**SECTION 905 -- PROPOSAL (CONTINUED)**

**PROJECT: STBG-0836-00(016)/109498301 - Panola**

**ADDENDUM**

**STATE OF MISSISSIPPI  
MISSISSIPPI DEPARTMENT OF TRANSPORTATION  
PLAN AND PROFILE OF  
PROPOSED STATE HIGHWAY  
FEDERAL AID PROJECT NO. STBG-0836-00(016)**

WK. NO. **TC-1**  
 SHEET NO. **8**

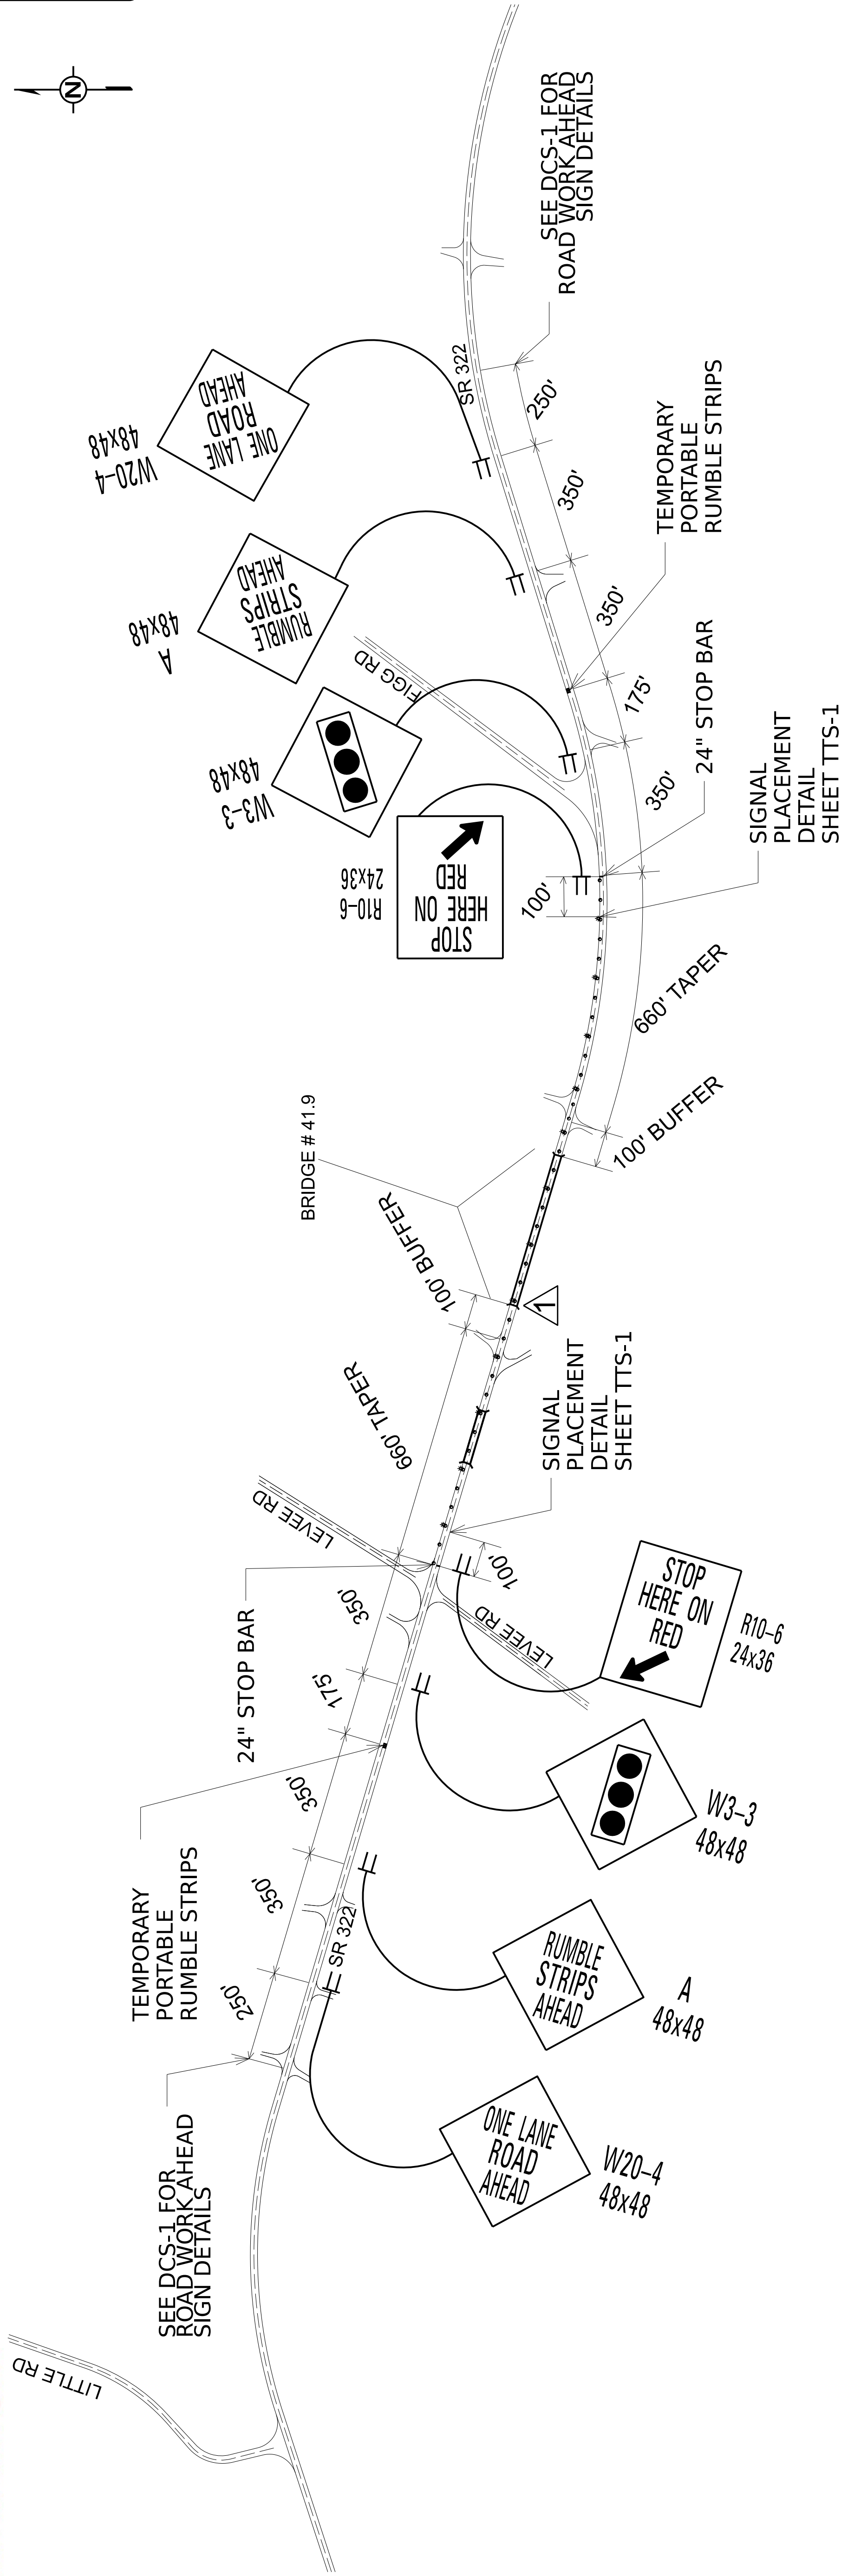
DATE	1st ORDER	ADDENDUM	2nd ORDER	BY	WK. NO.	DESCRIPTION
9/9/2024		X		EG	TC-1, TC-2	REPLACED CONCRETE MEDIAN BARRIER WITH FREE STANDING PLASTIC DRUMS, UPDATED QUANTITIES

ITEM	SIZE	COUNT
A	48x48	2
W3-3	48x48	2
W20-4	48x48	2
R10-6	24x36	2
TYPE B WARNING LIGHT		12
CHANGEABLE MESSAGE SIGN		2
FREE STANDING PLASTIC DRUM		38
TYPE 2A PORTABLE TRAFFIC SIGNAL		2
